FIELD INSPECTION

Project Name:	Mountain Valley Pipeline	Inspector:	Matthew Grant
Inspection Date:	Thursday, July 18, 2019	Project Contact:	Brian Clauto
Spread: Montgomery Co. MN275 MP230 St12193+45-1200+27 Franklin Co. FR290 MP247 St13063 FR293.01 MP251.1	Spread H	Weather (Wet/Dry/Rain):	Dry

FIELD INSPECTION PHOTO LOG

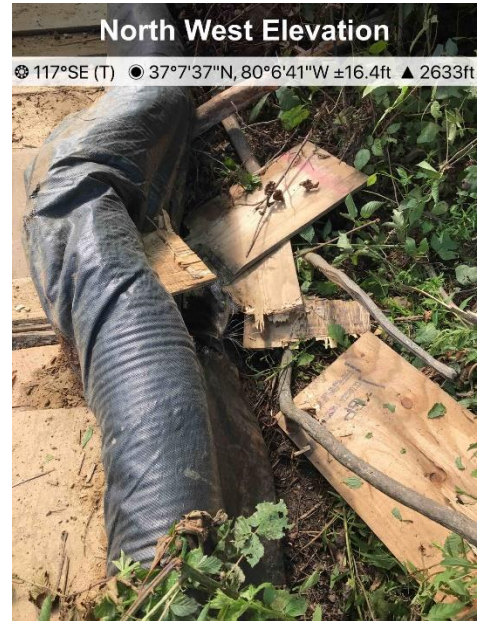
- Fig. 1 St12199 sump requires maintenance

- Fig. 2 S-G26 & S-G27 bridge sidewalls require maintenance

- Fig. 3. ECD in place above designated stream S-C21

Recommended Corrective Action: Maintain controls per the approved plan and annual standard and specs.
